S.A.T.	248 MV
area	n°

Service Bulletin

Subject: **Electric system sheath new routing**

Product: **Superveloce 800 (all versions)**
VIN from ZCGF110ABLV001230 up to ZCGNKGNU7MV001812

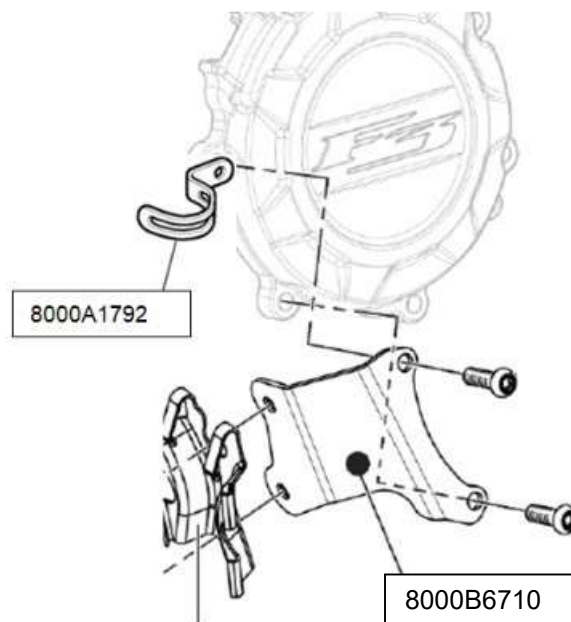
Cable positioning: the final result must be as shown in the picture below.

Cable repositioning procedure:

1. Remove the upper fixing screw of the canister bracket 8000B6710, and loosen the lower screw.

2. Insert the 8000A1792 clamp between the bracket and the ignition pickup cover.
3. Re-tighten the two fixing screws of the canister bracket to the prescribed torque ($8 \div 10 \text{ Nm}$)

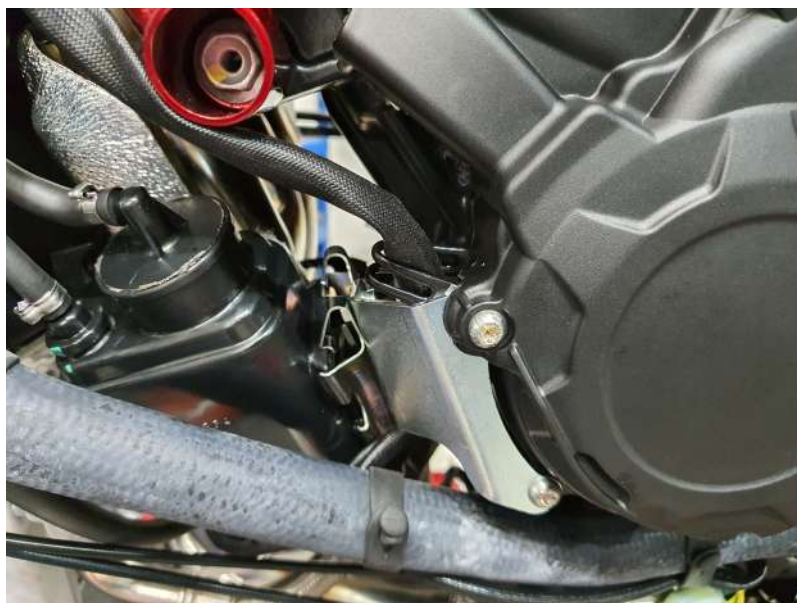
4. Pass the sheath in front of the front engine mount, and wind the tongue of the 8000A1792 clamp around it in order to constrain the sheath's path. The tongue must wrap around the sheath in order to avoid accidental releases.
